LINCOLN CITY/LANCASTER COUNTY PLANNING STAFF REPORT

P.A.S.#: View Point North Community Unit Plan
Co Special Permit #196, City Special Permit # 1976
Preliminary Plat 02014

Date: August 21, 2002

PROPOSAL: A Community Unit Plan to create 14 lots and 5 outlots.

VIEW POINTE NORTH PRELIMINARY PLAT & COMMUNITY UNIT PLAN

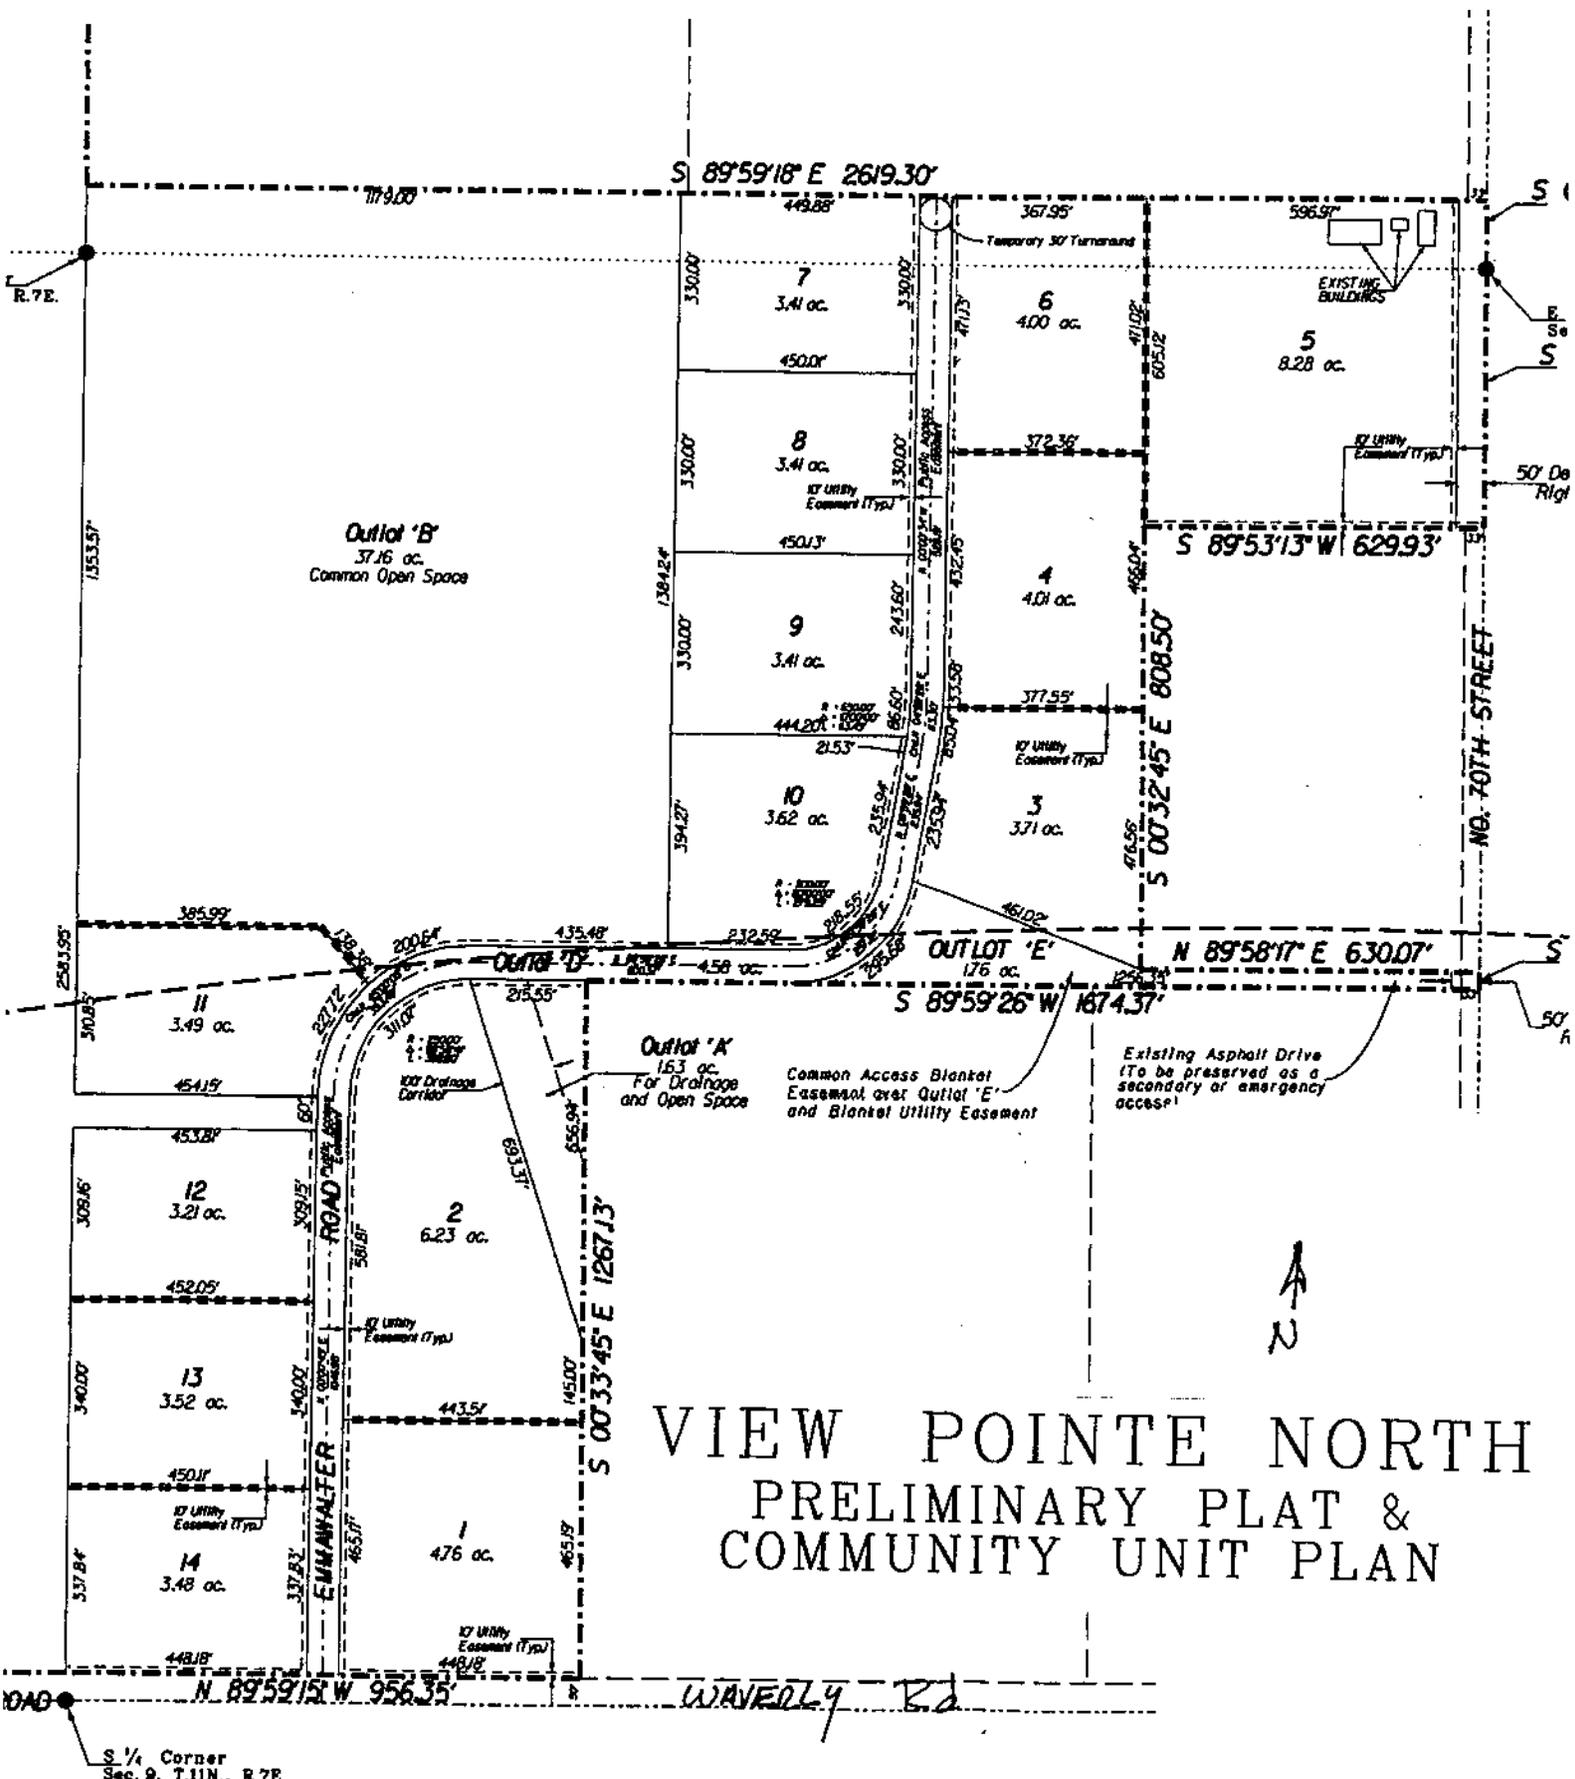
1) The typical section is incomplete. No detail on fill sections is shown. No slope for shoulder is shown.

2) General Note 1 refers to Lovegrove Lane which has been changed to Emmawalter Road. Existing asphalt drive on Outlot "E" should be removed to agree with access relinquishment described in General Note 1.

3) Temporary dead end requires a 22' Type III barricade.

4) The radius of the returns of Emmawalter Road at Waverly Road should be 50 feet.

5) The culvert at Sta. 15 + 30 shall be designed for a 25 year storm and shall be designed for the entire drainage area upstream from Emmawalter Road. The pond is not a "designed" dam and has no permanent protection to keep it in place.

1. Show a roadway cross section that meets design standards.

2. Descriptions of the outlet and drainage culverts from the existing pond in Outlot "B" are illegible.

3. The use of the existing asphalt driveway in Outlot "E" as a secondary/emergency access is in conflict with item #1 in the General Notes.

4. The areas designated as Outlot "A" and Outlot "B" are not consistent between the Preliminary Plat site plan and the Grading and Drainage Plan.

5. Define the boundary and purpose of Outlot "D".
10. The Health Department notes that water is satisfactory and the lots are large enough for lagoons.
11. The applicant is not requesting a 20% bonus for farmland protection.
12. This application is in split jurisdiction and requires approval by both the City and County.

5. Define the boundary and purpose of Outlot "D".
- 1.3 Revise note # 1 to reference Emmawalter Road, not Lovegrove Lane.
 - 1.4 Revise note # 1 to include Outlot "E" access.

- 1.5 Note the purpose of Outlot "E" and "D".
 - 1.6 Show the easement for the power transmission line on the western portion of the property.
 - 1.7 Show the "sheet of" numbers on sheet 1.

- 1.8 Label sheet one as the Site Plan.
 - 1.9 Correct "contoured row crop" on sheet 2 of 4.
 - 1.10 Add to note #12 that front yard setbacks apply to the south lot line of Lot 11 and the north lot line of Lot 12 for future street purposes.
